CITY OF ALBUQUERQUE

**RE: Signal Village Subdivision
Signal and Ventura NE
Grading Plan Stamp Date: 7/6/18
Drainage Report Stamp Date: 7/6/18
Hydrology File: C20D078**

Based on the submittal received 7/11/18, the above referenced project cannot be approved for Preliminary Plat until the following are corrected:

SIGNAL VILLAGE	GRADING AND DRAINAGE PLAN
----------------	---------------------------

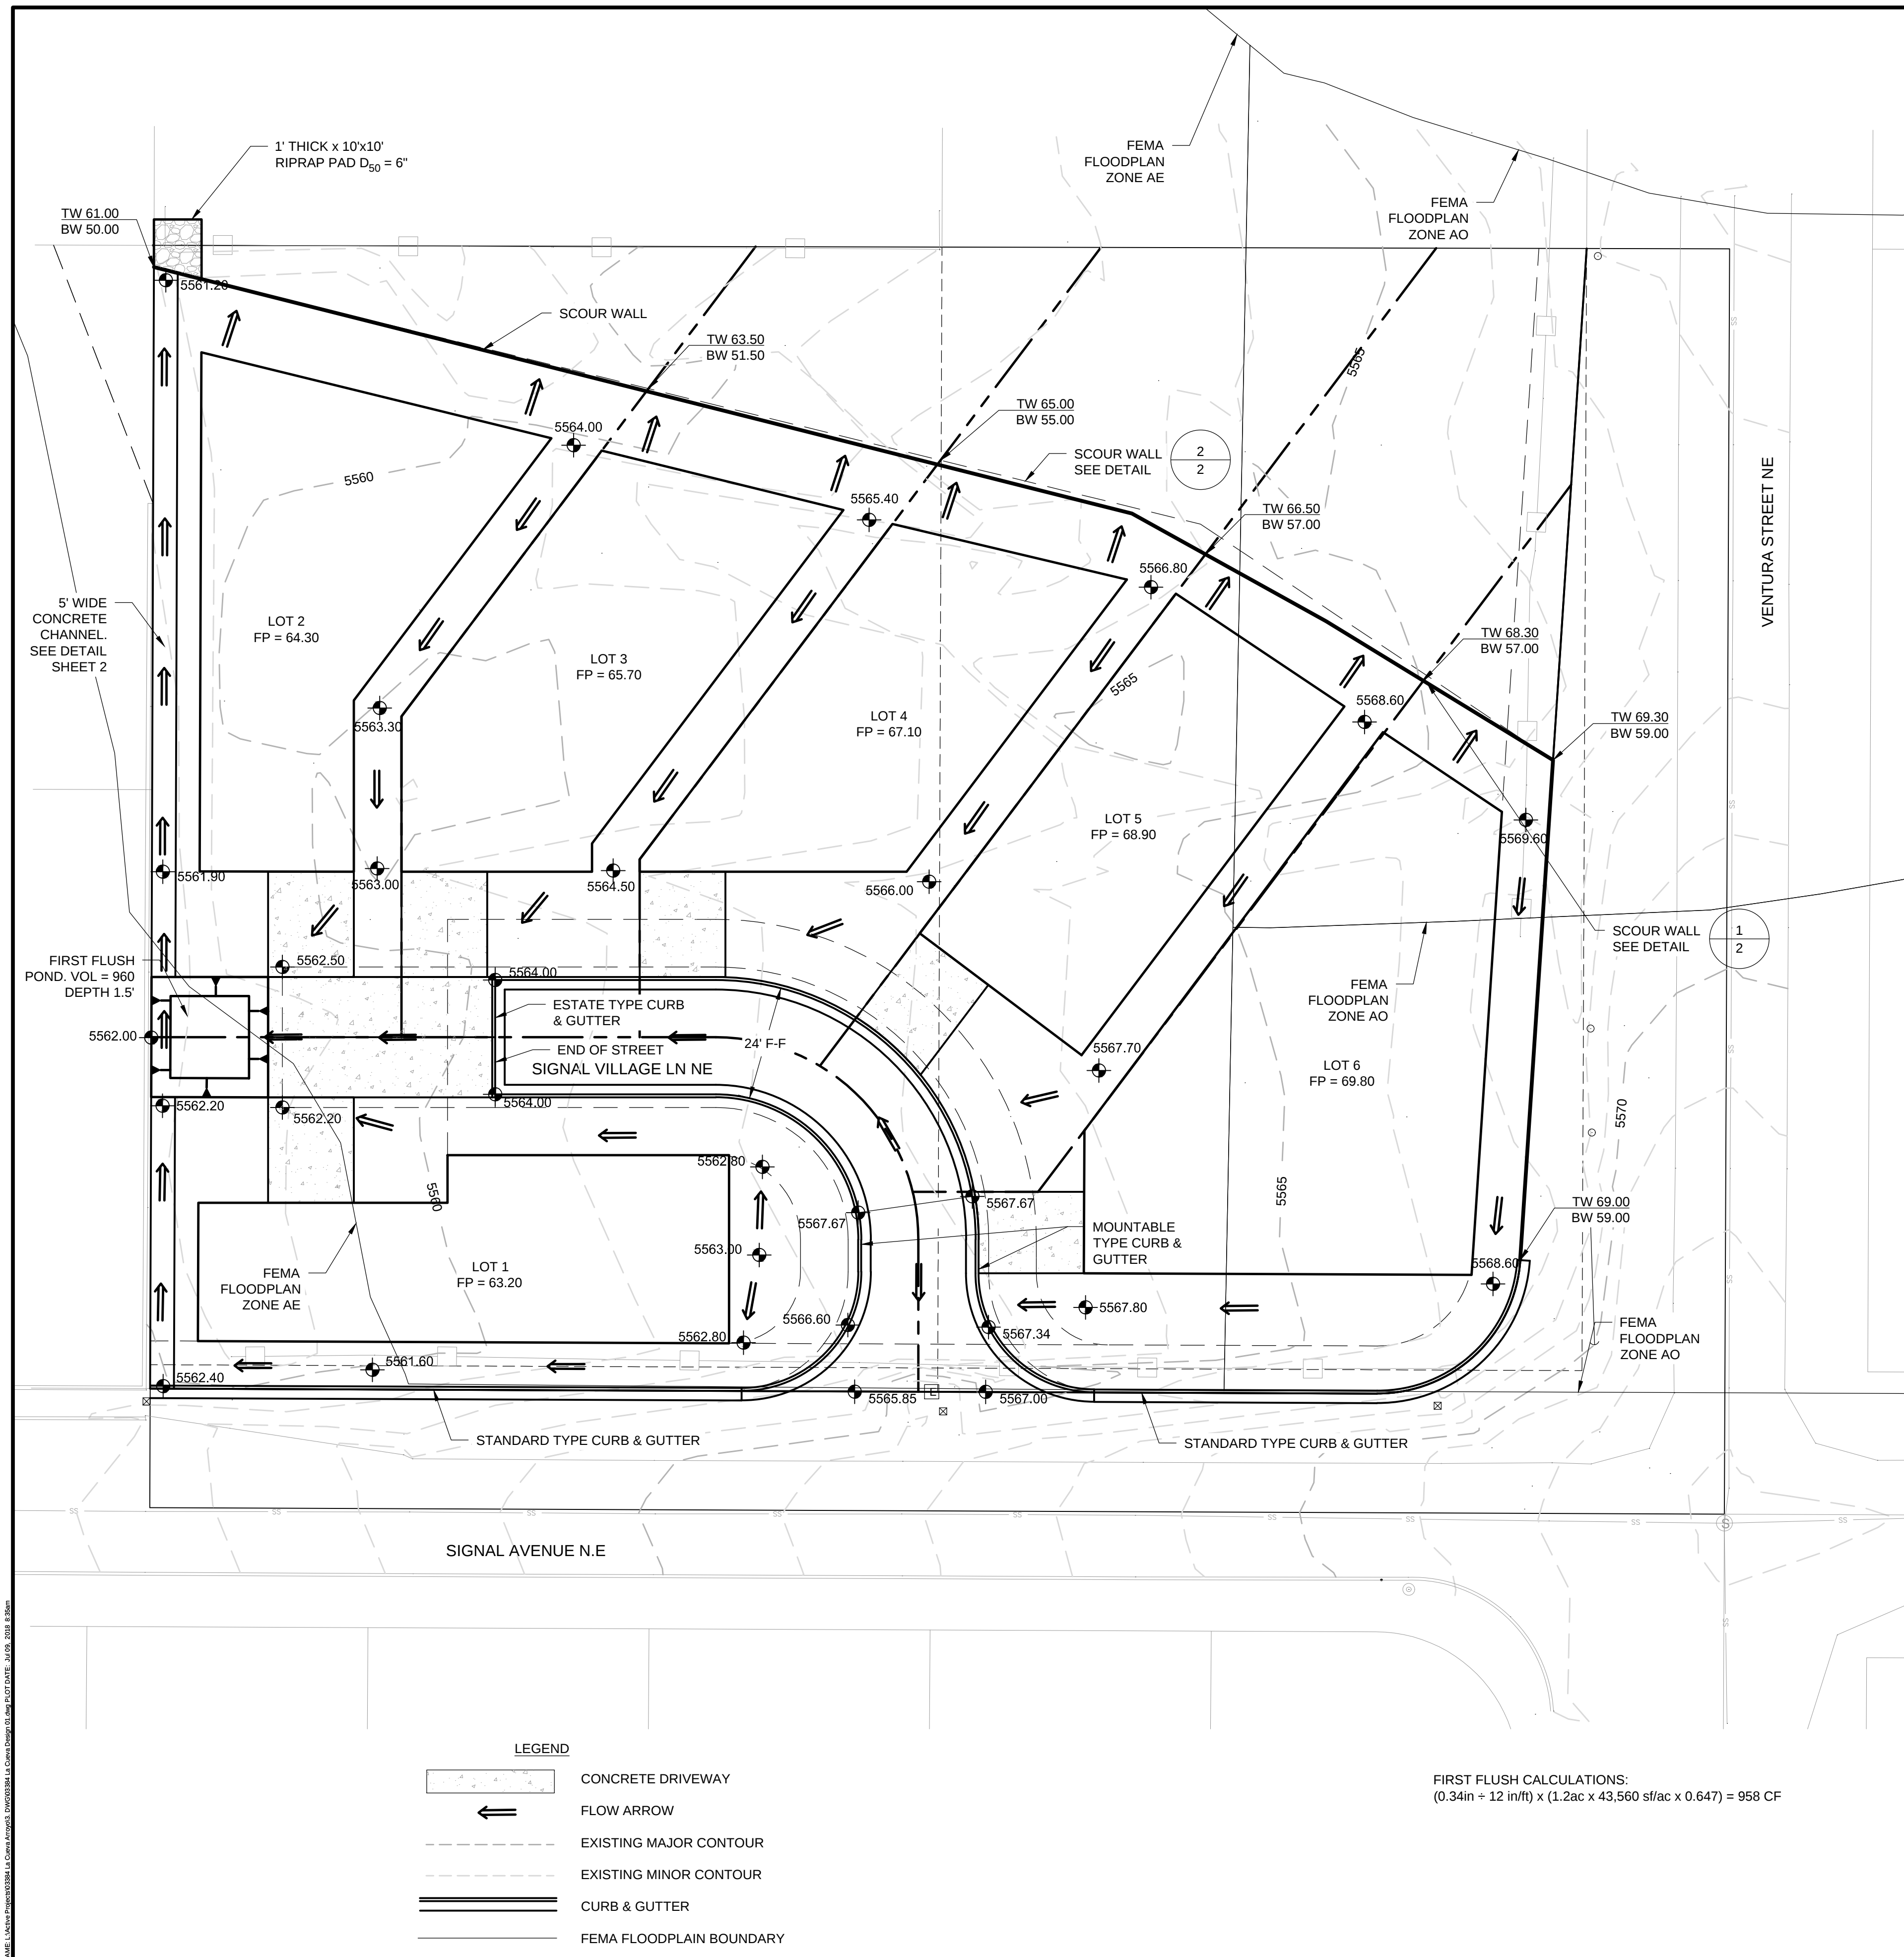
1. Right of Way and Plat boundary lines do not appear to be accurately shown on the grading plan. Label the ROW width and show both sides and centerline. Also dimension the paving, face-to-face of curb, and sidewalks on both sides of the centerline.

2. Provide first flush calculations and additional details for the first flush pond such as dimensions and top and bottom of pond elevations. First flush notes are not legible. Show the water surface elevations for both the first flush volume and the 100-yr volume.

3. Typical sections are required at all retaining walls (not just the scour wall) at the point of maximum retainage showing existing ground, proposed grades, lot lines, and dimensions. Wall footers must not encroach into public right of way or adjacent properties without a written agreement from the adjacent land owner.

4. The typical section provided for the scour wall is illegible and is not supported by the scour calculations. Details such as maximum water surface, scour depths, arroyo thalweg are also missing. Will the scour wall be one uniform depth or variable? Each case must be shown; provide structural design calculations.

7. Provide topographic survey data along the west edge of the property and across the property line; include existing elevations on the west side of the existing wall/fence. A new retaining wall will be required and should be shown on the plan view and add a typical section with dimensions.

8. Frontage improvements will be required on Ventura St. and Signal Ave. that must be shown on the G&D plan. Typical sections must be shown on the G&D Plan for all roads both onsite and offsite. The sections and the plans should show both the full planned width and the portion to be constructed with this project, along with any temporary transitions at the ends.
